**Realistic loss-of-coolant accident (LOCA) Evaluation Methodology
Applied to the Full Spectrum of Break Sizes
(FULL SPECTRUM™ LOCA Methodology)**

WCAP-16996-P/ WCAP-16996-NP Volumes I, II and III, Revision 0, “Realistic loss-off-coolant accident [LOCA] Evaluation Methodology Applied to the Full Spectrum of Break sizes (FULL SPECTRUM™ LOCA Methodology)”

REQUEST FOR ADDITIONAL INFORMATION (RAI)

FIRST SET OF RAI QUESTIONS

Figure: Illustration of PCT Response to Break Size Variation for Appendix K SBLOCA Analysis

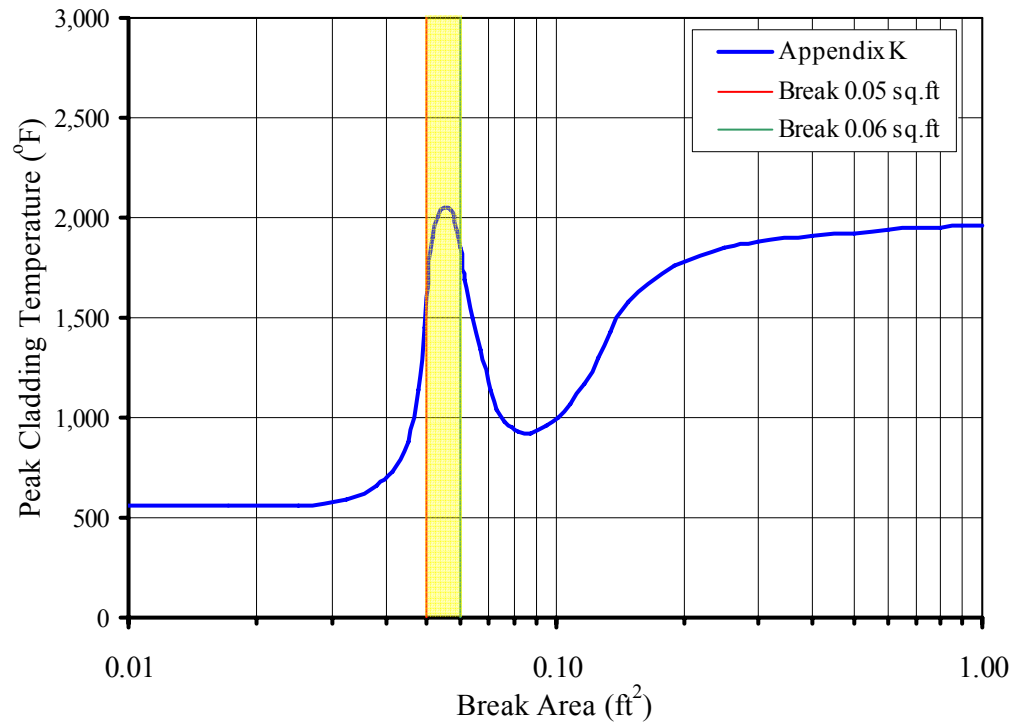
] Please present the updated Figures 31.3-4 to 31.3-7 and Tables 31.3-1a and 31.3 1b to illustrate the obtained results. If this approach does not guarantee adequate resolution of the worst break, please consider an alternative method as discussed in the following paragraph. Please be aware that for some plants the PCT can increase by a few hundred degrees Fahrenheit when the break size changes from 0.05 ft^2 to 0.06 ft^2 . Thus, it has been shown for some plants that the PCT can increase by approximately 100°F for a small break area increase of 0.005 ft^2 so that the 0.055 ft^2 break PCT is higher than both the 0.05 ft^2 and 0.06 ft^2 break. This limiting break is characterized by RCS pressure that just depressurizes to a pressure within several psi of the safety injection tank (SIT) actuation pressure. Because such behavior characterizes most plants, it is necessary to resolve the size of the worst break

controlled entirely by the HPSI injection only. While this low range of small break sizes is most pronounced under Appendix K analysis assumptions, it still needs to be evaluated in the best estimate space since future increased power levels and linear heat generation limits will also produce such a temperature spike for such a small break window. The included figure illustrates the described PCT behavior. In addition, sometimes this worst break size can be just slightly larger than that at which SIT injection is prevented. In this case, a small amount of injection after a deeper core uncover can often lead to the worst break because SIT injection quickly terminates with only a small increase in core level as the RCS pressure can quickly increase with the small level change.

Please also show the spectrum evaluation for the Beaver Valley Unit 1 three-loop PWR plant considered in WCAP-16996-P/WCAP-16996-NP, Volumes I, II, and III, Revision 0, Section 26.3, "Beaver Valley Unit 1 Nuclear Power Plant," and compare the break spectrum results with the Appendix K more limiting analysis.
